CITY OF SOUTHGATE PLANNING COMMISSION AGENDA

PROPOSED NEW - GAS STATION

Carlisle | Wortman
ASSOCIATES, INC.

Special Condition and Site Plan Review

Sheet Title:
PROPOSED SITE PLAN

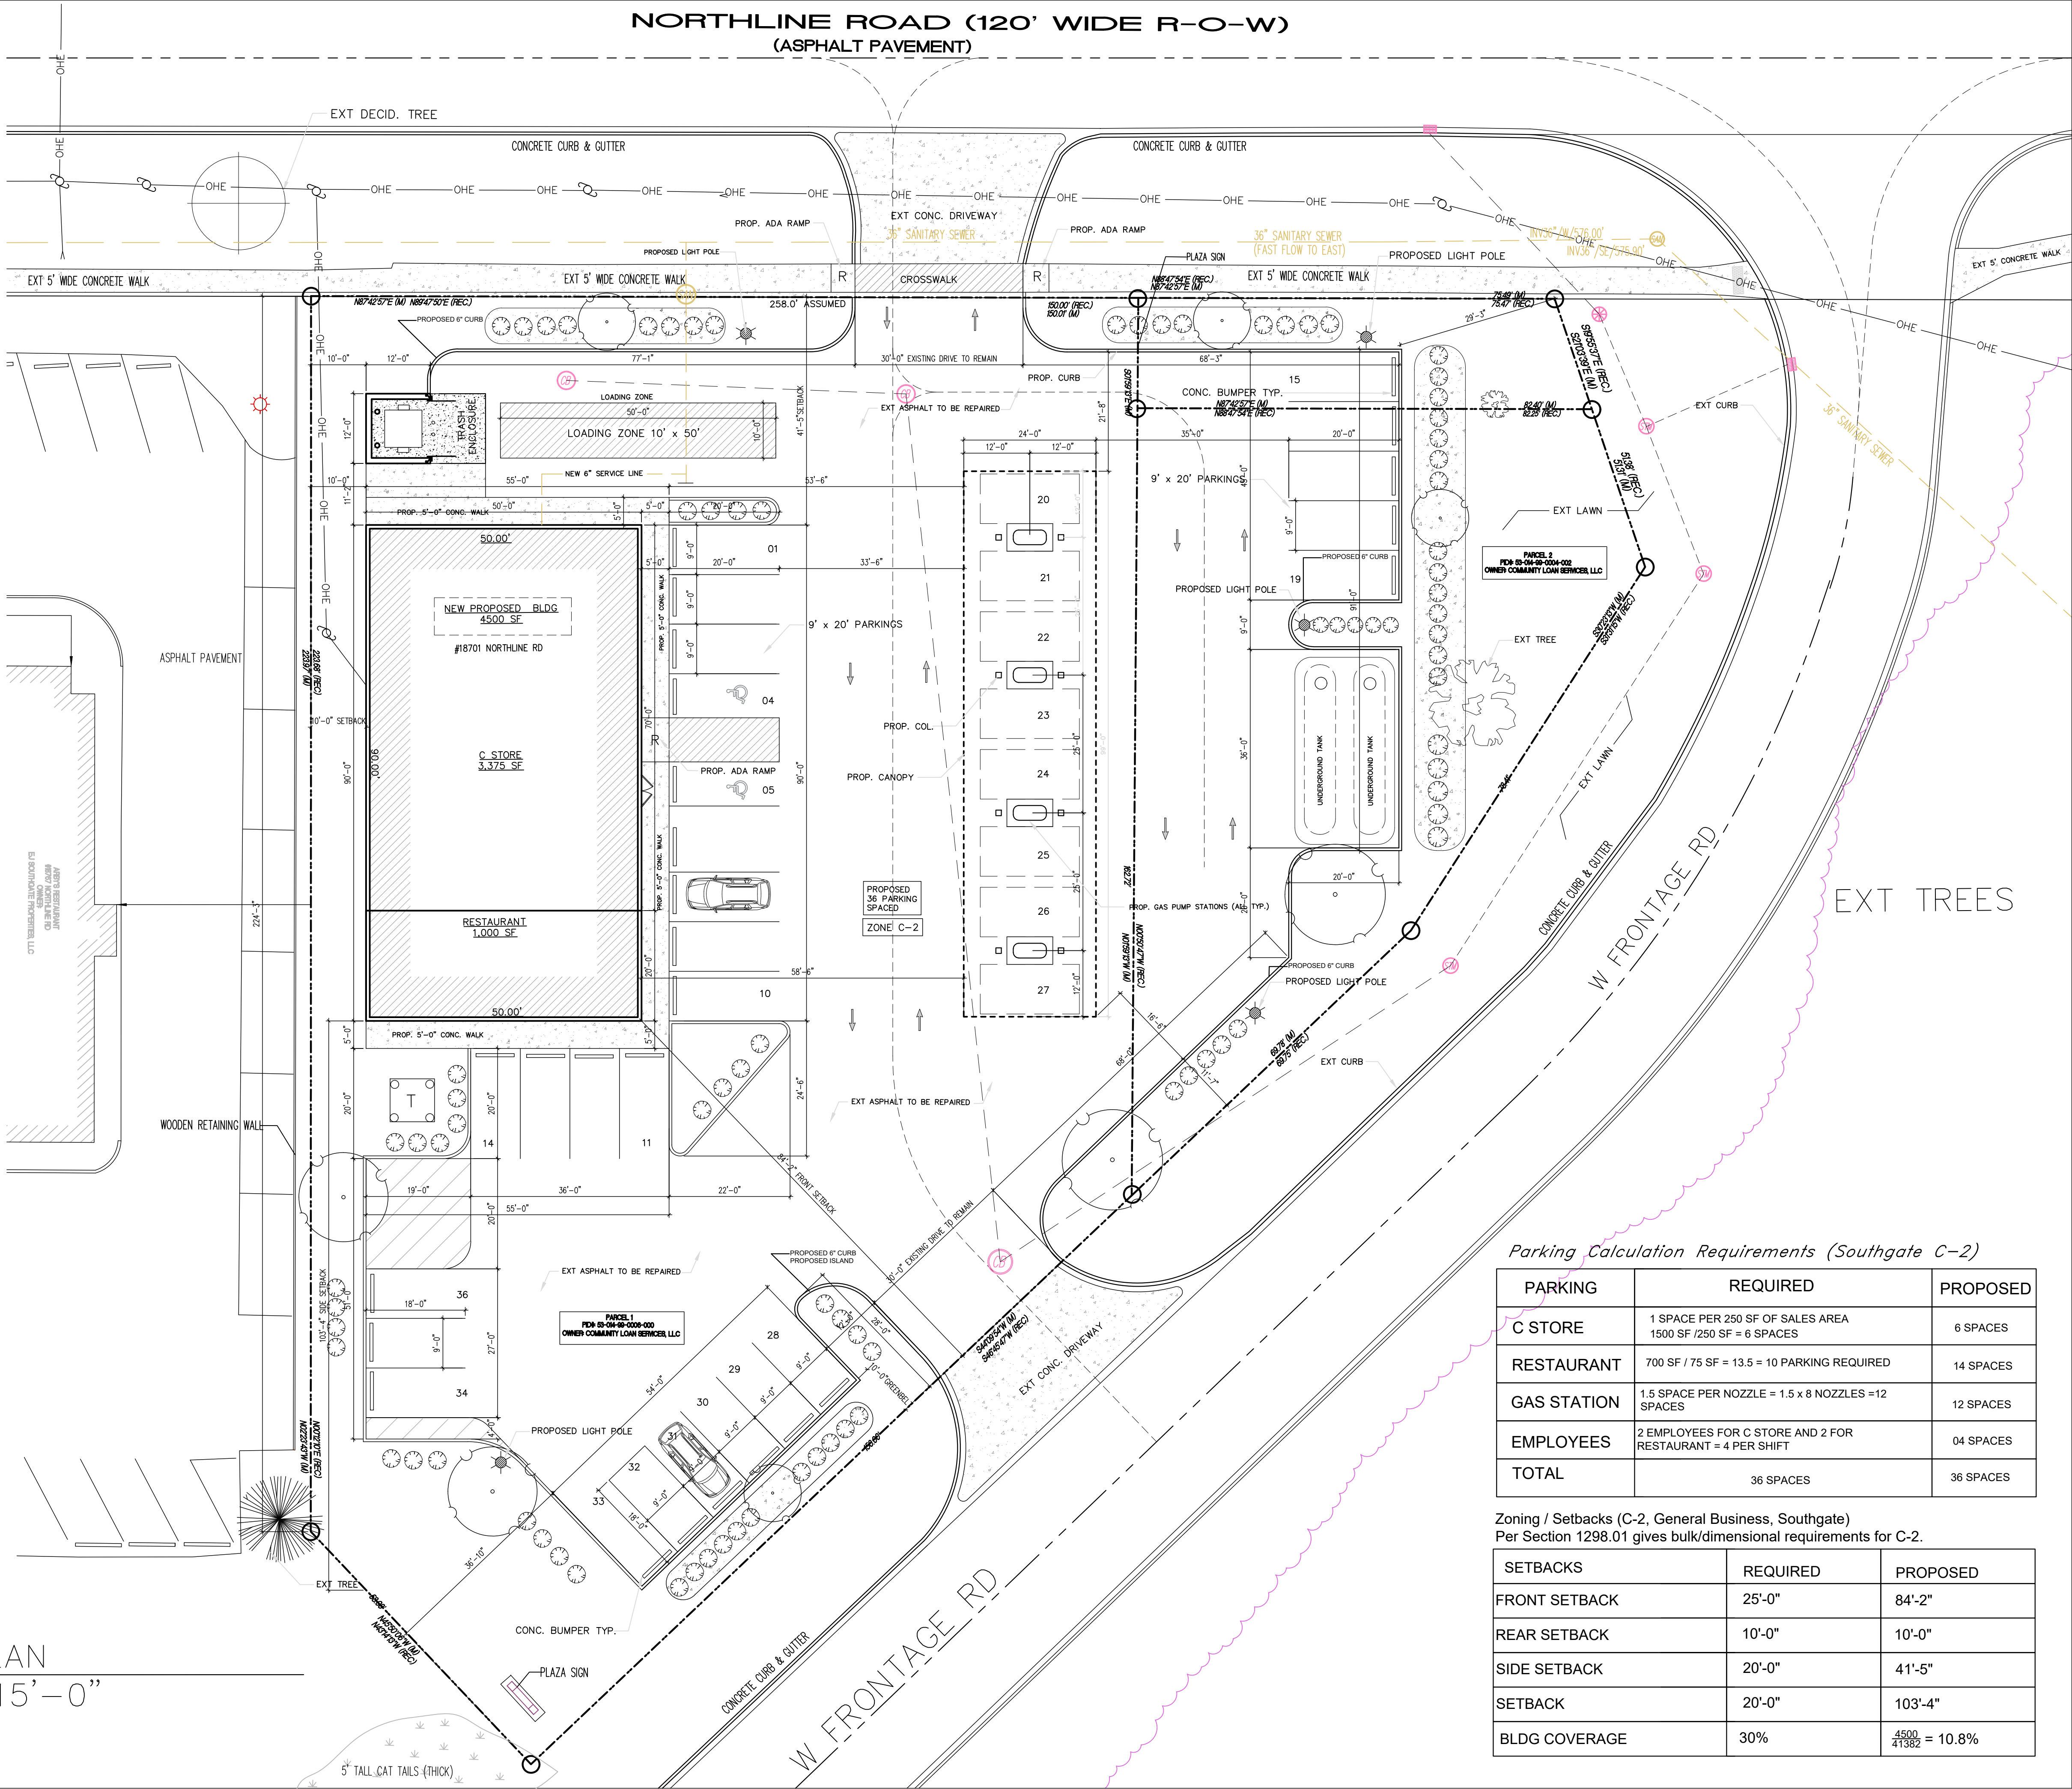
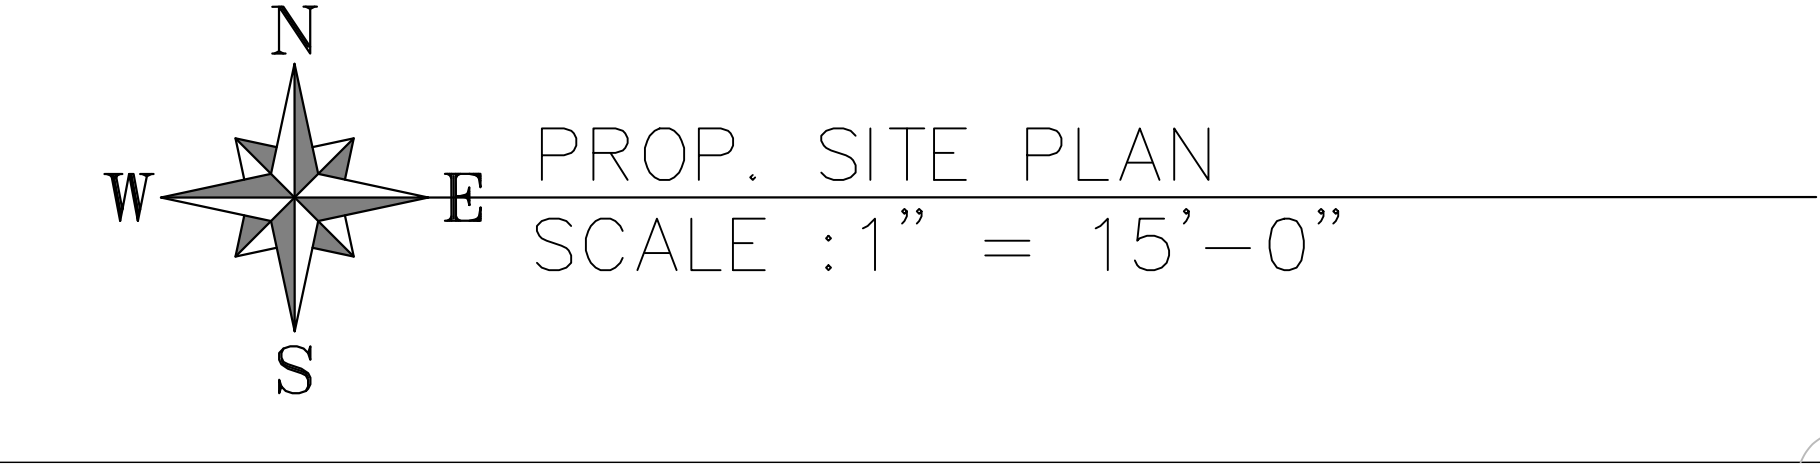
1. Thirty-five (35) spaces are counted on sheet SP-101 whereas the parking calculation table proposes thirty-six (36) spaces.
2. The restaurant calculation for parking is as follows “700 SF/75 SF = 13.5 = 10 parking required.” This should be corrected to “700 SF/75 SF = 9.33 spaces.” We ask the applicant to confirm if 14 spaces are still proposed, or if the number will be reduced based on the new calculation.
3. The parking space directly south of the ADA space # 5, appears to have a greater width than the rest of the proposed spaces. We ask the applicant to clarify if the width will be reduced.

Section 1292.03 requires maneuvering lane width for 90-degree parking to measure at least twenty-two (22) feet. Current plans exceed this requirement, showing measurements of thirty-three (33) and thirty-five (35) feet. Parking space dimensions have also been provided and vary throughout the site. The parking area in front of the building and northeast corner show dimensions of 9x20 feet, which will need to be increased to 10x20 feet. The parking area on the southwest corner shows dimensions of 9x18 feet, which will need to be increased to at least 10x19 feet.

Items to be Addressed: 1) Address parking discrepancies #1-3. 2) Revise parking space dimensions to meet ordinance requirements. 3) Clarify timing and frequency of deliveries.
